U.S. Department of Transportation
Pipeline and Hazardous Materials
Safety Administration

Ref. No. 10-0103

This responds to your April 28, 2010 email requesting clarification of the Hazardous Materials Regulations (HMR; 49 CFR Parts 171-180). You provide a description and pictures of a Class 7 (radioactive) material in a Type A package, which you refer to as a blender densitometer. The Type A package is attached to the frame of a machine mounted on a trailer. A steel sleeve that fits over the package is bolted in place using existing bolt holes on the frame of the Type A package to provide additional shielding. Specifically, you ask if the steel sleeve meets the definition of an overpack in the HMR.

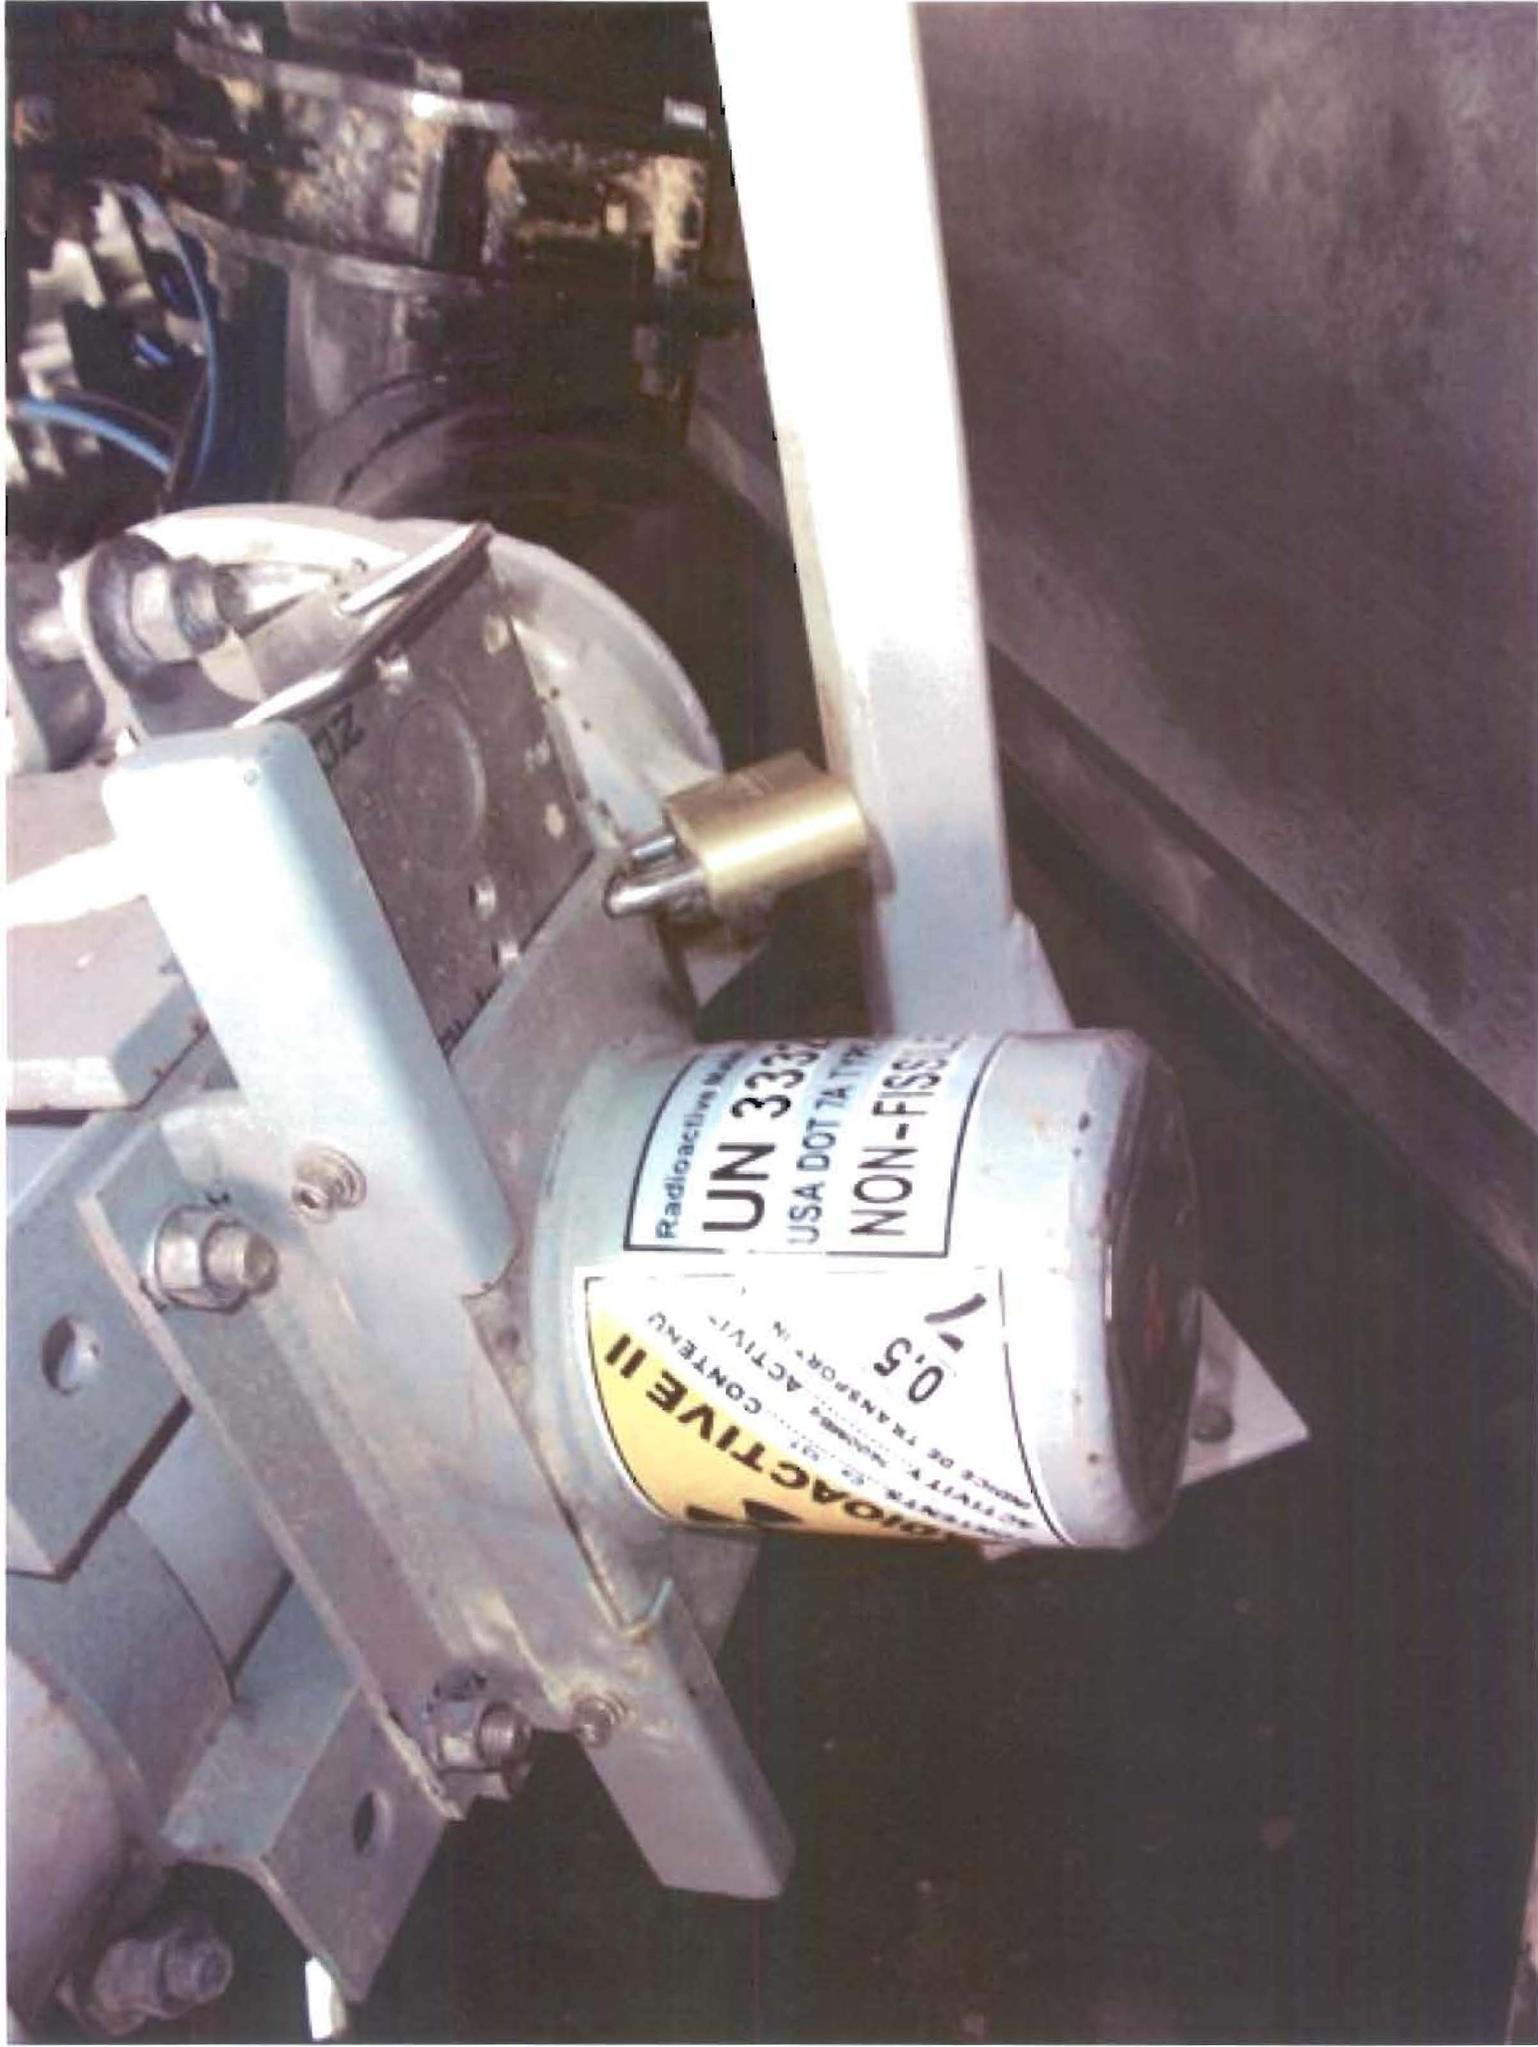
What function is the device around the packaging meant to fulfill? In your both of your submitted pictures, the questionable package itself is labeled "Yellow-II" and the questionable "overpack" is also labeled "Yellow-II"

We have an inquiry on our blender densitometers. Calfrac has installed additional shielding on our blender densitometers this shielding was in the form of a steel sleeve that fits over package and is bolted in place using existing bolt holes that were on the frame of Type "A" package. The question that we have is with the addition of this "sleeve" would be considered an over pack? I have attached pictures before and after installation of sleeve.

The answer is no. An overpack is defined in § 171.8 to mean an enclosure used by a single consignor to provide protection or convenience in the handling of a package or to consolidate two or more packages. An example of an overpack is one or more packages placed in a protective outer packaging such as a box or crate. The steel sleeve semi-permanently attached to the Type A package is considered an attachment to the Type A package; therefore, it does not meet the definition of an overpack.
